Our ref: 21/00790/AS Land between Woodchuch Road and Appledore Road, Tenterden

Re: 21/00790/AS – Land and between Woodchurch Road and Appledore Road, Tenterden

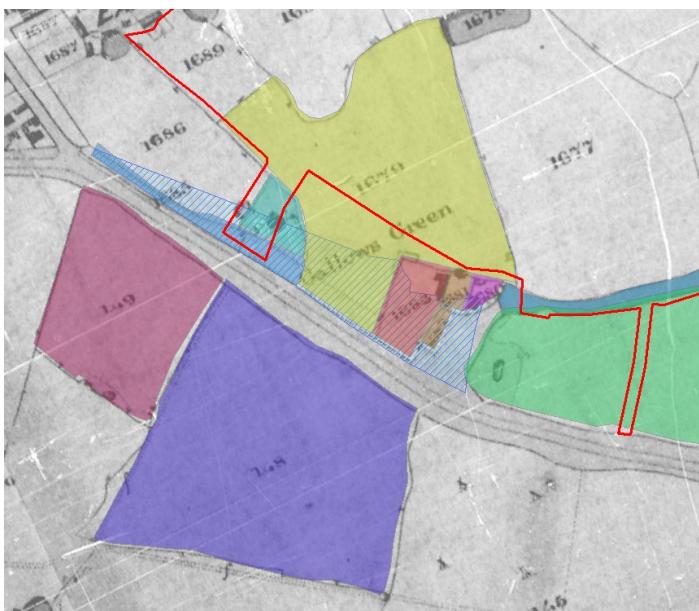
22. As the image below shows, the area of roadside waste (hatched in blue) is the extent of the 'green' as captured on the Adams map of 1822, where the gallows would have once stood on the large area of roadside waste during the 18th century and earlier. As such, it was around this area of 'green' that the various fields were enclosed, and named on both the Adams and Tithe maps with 'gallows' in their nomenclature. By 1843 there had been substantial encroachment into this area by the recorded cottages and gardens, including Tithe plots 1680, 1681, 1682 and 1683, and various historic documents refer to these dwellings as "being at a place called Gallows Green". I do not believe that the evidence can be any clearer that the site of the gallows and the 'green' on which they stood lies firmly outside of the application area, and that 'Gallows Green' as mentioned in documents and annotated on historic maps refers to this cluster of early roadside ribbon development along Appledore Road.
